# CONSTRUCTION PLANS FOR THE HILLS AT LORSON RANCH FILING NO. 2

## STREET & STORM SEWER CONSTRUCTION PLANS

**THE RIDGE AT LORSON RANCH FIL NO. 2  
STREET & STORM SEWER  
CONSTRUCTION PLANS**

**ROADWAY DETAIL SHEET**

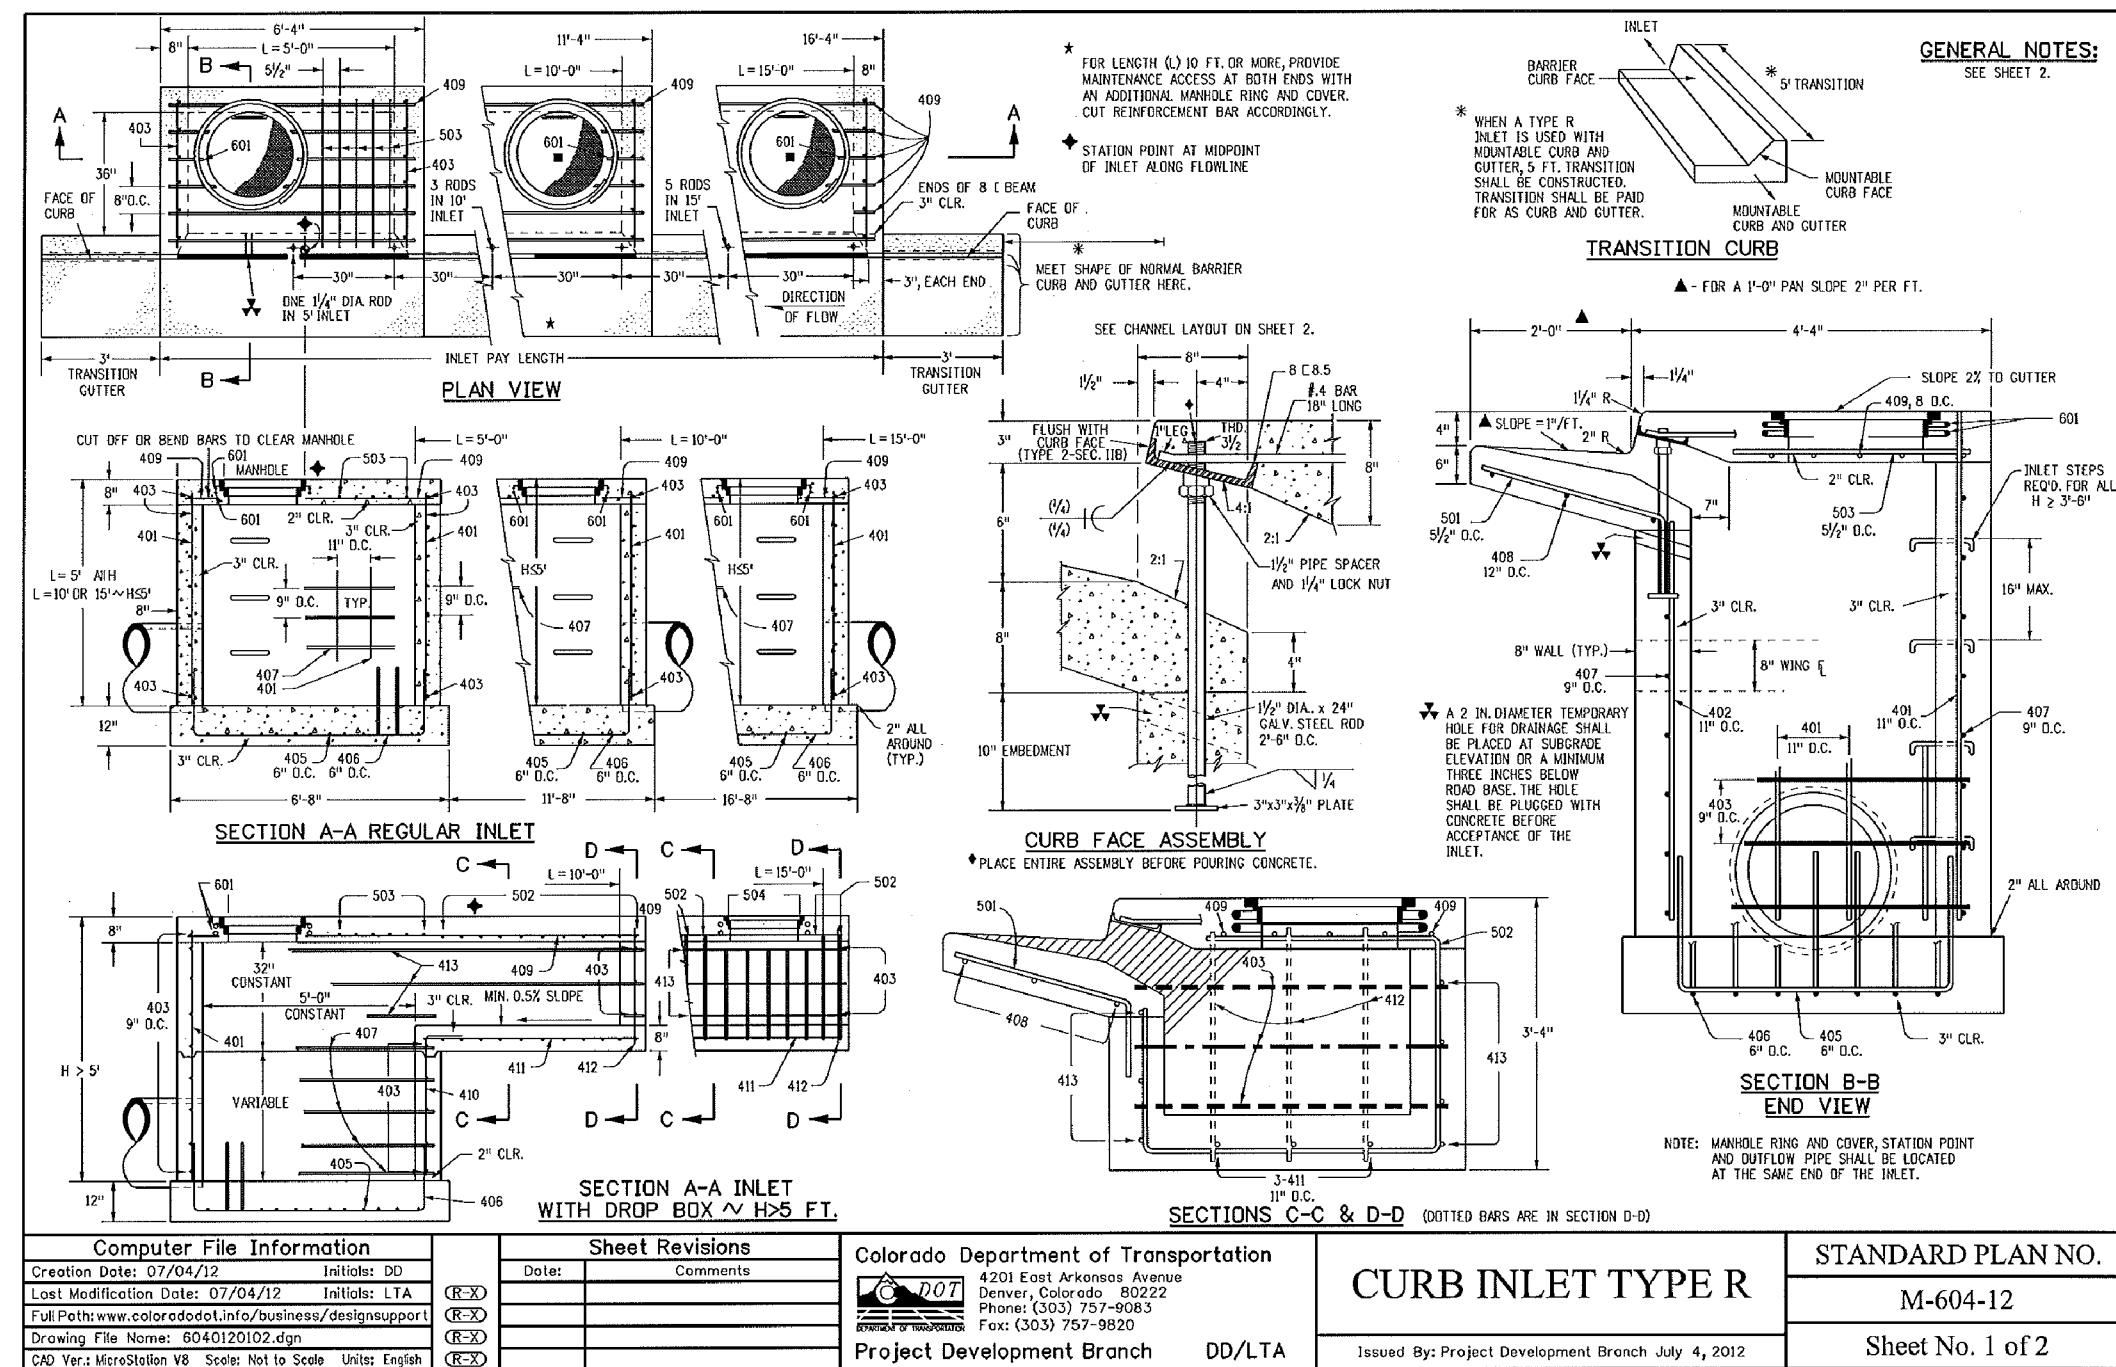
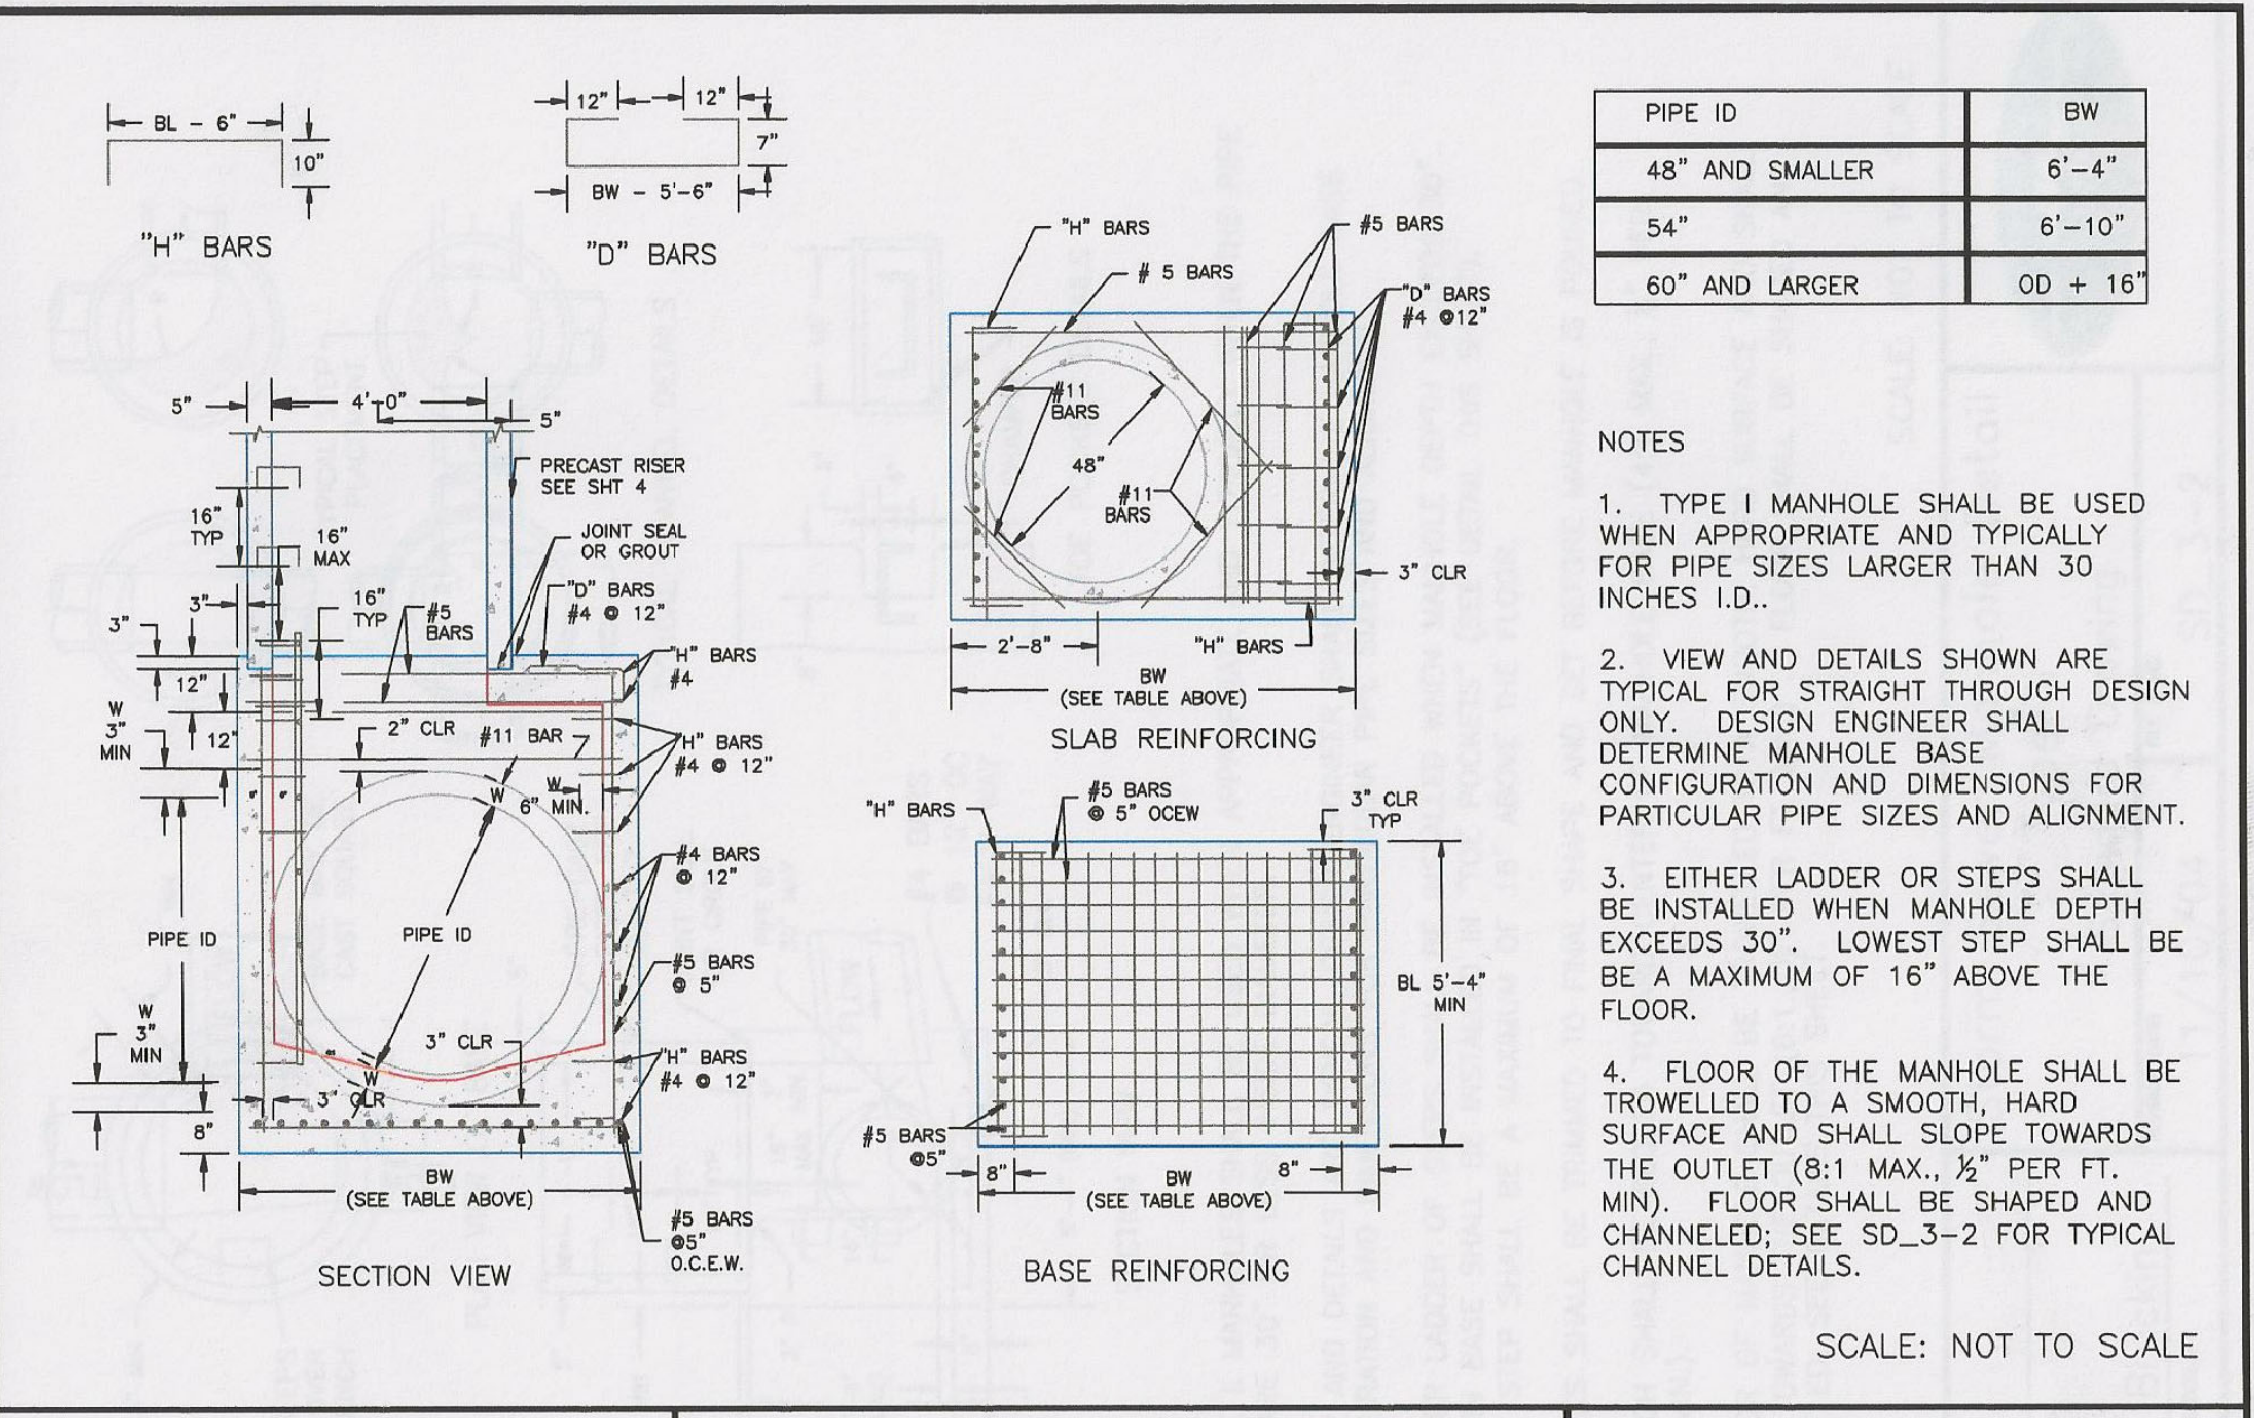
Update with most current parallel ped ramp detail, dated 6/23/20
